**Lancashire Association of Local Councils Fylde Area Committee Energy Working Group**  
Interested Party Number - 20053845

**Summary of  
UPDATE TO RELEVANT REPRESENTATION AND  
INITIAL COMMENTS ON APPLICANTS' FEEDBACK  
ON THE PROPOSED  
MORGAN AND MORECAMBE OFFSHORE WIND FARMS TRANSMISSION ASSETS  
DEVELOPMENT CONSENT ORDER  
PLANNING INSPECTORATE REFERENCE NUMBER: EN020028**

**MORGAN AND MORECAMBE OFFSHORE WIND FARMS TRANSMISSION ASSETS  
DEVELOPMENT CONSENT ORDER**

**PLANNING INSPECTORATE REFERENCE NUMBER: EN020028**

455 **Figure A1** - High-Level Environmental and Community Constraints for North West taken from Figure 32 of the HNDR.

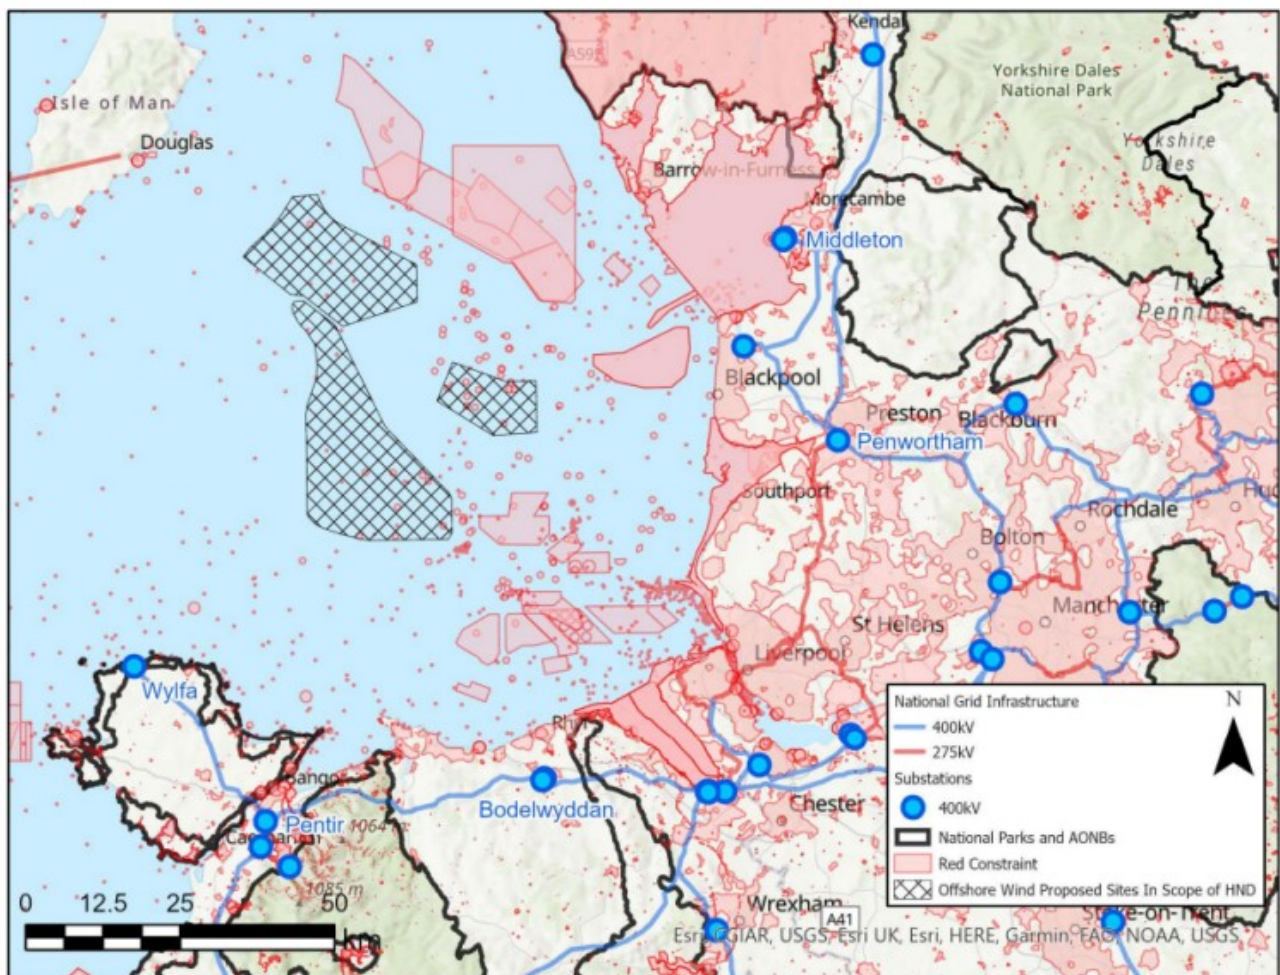
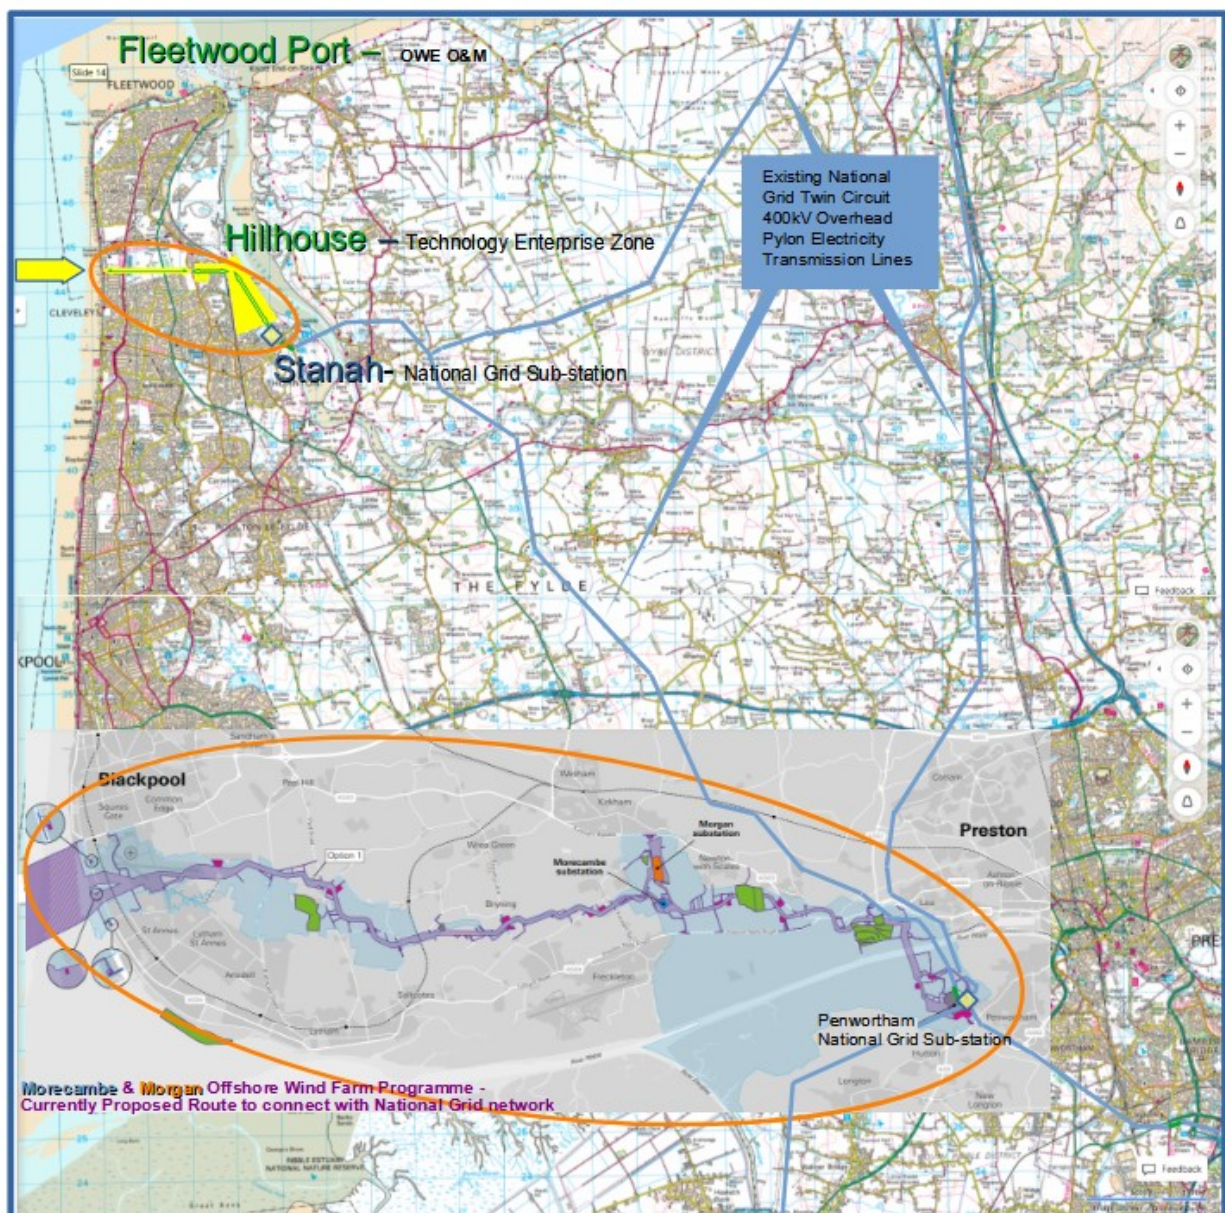
- It would appear that National Grid adopted a recommendation of route proposed by the Applicants that was already recognised as being non-compliant., with amber ratings for all criteria. There is no reference in the HNDR to an assessment of a route utilising Stanah or a comparison with the routes that were recommended based on the assumptions provided by the Applicants. In fact the HNDR is completely silent on “Stanah”, despite showing it clearly on the maps in HNDR Figure 32, just north of Blackpool, and reproduced at Figure A1 in this document.

The Stanah substation and its connectivity to the 400kV network and Penwortham can be clearly seen located north of Blackpool. It is also clearly closer to the coast and the Morgan and Morecambe arrays. Than Penwortham It also offers the capability of avoiding all identified High Level Environmental Constraints. By comparison the Applicants' route conflicts with multiple offshore and onshore environmental and community constraints.

465 **Figure A2** – Comparison of routes connecting to Penwortham, utilising the existing infrastructure  
via Stanah and HTEZ, and the completely new infrastructure as proposed by the Project.

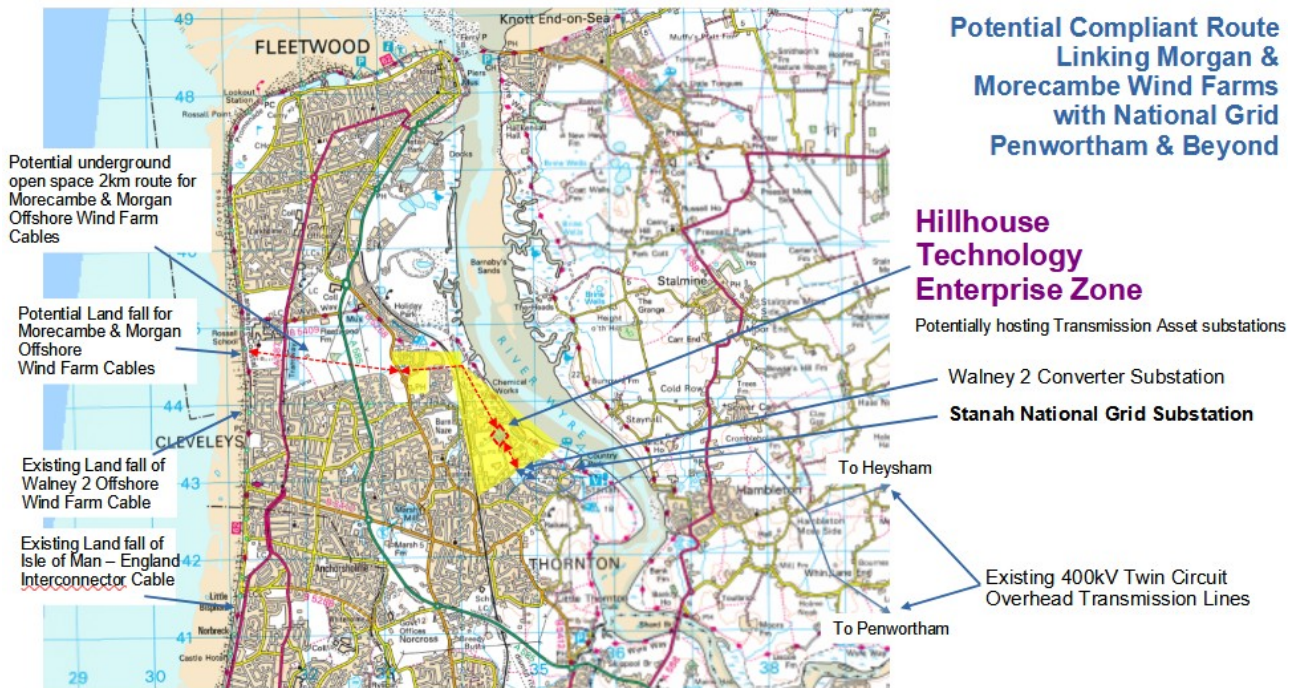
The following figure was also provided in the earlier EWG RR. It shows the order of magnitude  
470 difference in scale of the new infrastructure being proposed in the 30km of cable corridors and  
Greenbelt development of converter substations, as compared to that of only 2km of  
undergrounding of cables across open space and the utilising of the established energy development  
infrastructure.
